# Access Compliance Report

### (Curb Ramps)

Intersection ID: 46733	Main Street: DARCY_HOPKINS_DR	Cross Street: BEAVER_BROOK_WY	Location: NE
ADA ID: 6095BF48391B	Ramp Type: Perp	Initial Pass/Fail: Fail	Overall Compliance: No
		Severity Score: 8.75

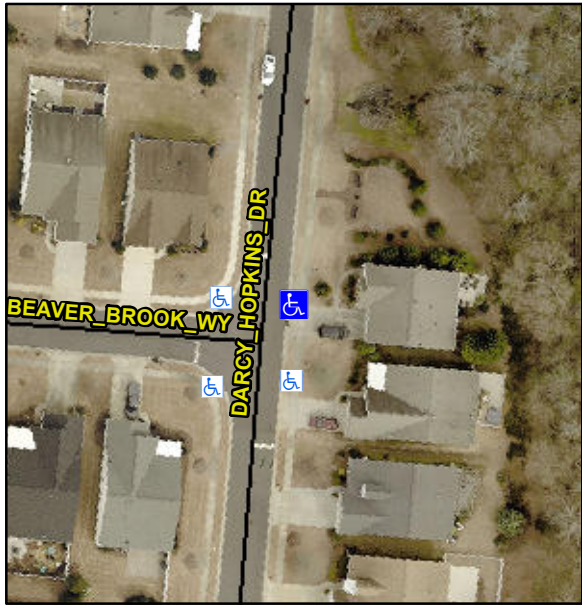
Codes/Mitigation Info/Possible Solution			Field Measurements/Component Compliance					
	Possible Solutions:		Compliance	Description	Data	Compliance	Description	Data
	Remove & Replace Entire Ramp.		N/A	Ramp Length (in)	48.0	Yes	Ramp Slope (%)	7.0
			No	Ramp Width (in)	46.5	Yes	Ramp XSlope (%)	0.2
			N/A	Flare Type LT	N/A	N/A	Flare Type RT	N/A
			N/A	Flare Slope LT (%)	N/A	N/A	Flare Slope RT (%)	N/A
			N/A	Flare Traversable LT?	N/A	N/A	Flare Traversable RT?	N/A
			N/A	Landing Length (in)	N/A	N/A	DWS Provided?	N/A
			N/A	Landing Width (in)	N/A	N/A	DWS Contrast?	N/A
			N/A	Landing Slope (%)	N/A	N/A	DWS Length (in)	N/A
			N/A	Landing X Slope (%)	N/A	N/A	DWS Full Width?	N/A
Surveyor Notes:		N/A	N/A	Landing Curb? (Y/N)	N/A	N/A	DWS Offset (in)	N/A
PROW/ADA:		Not Found, R304.5.1	N/A	Shared Landing?	N/A			
			N/A	Gutter Ponding?	N/A	N/A	Gutter Slope (%)	N/A
			N/A	Gutter Lip Ht (in)	N/A	N/A	Gutter X Slope (%)	N/A
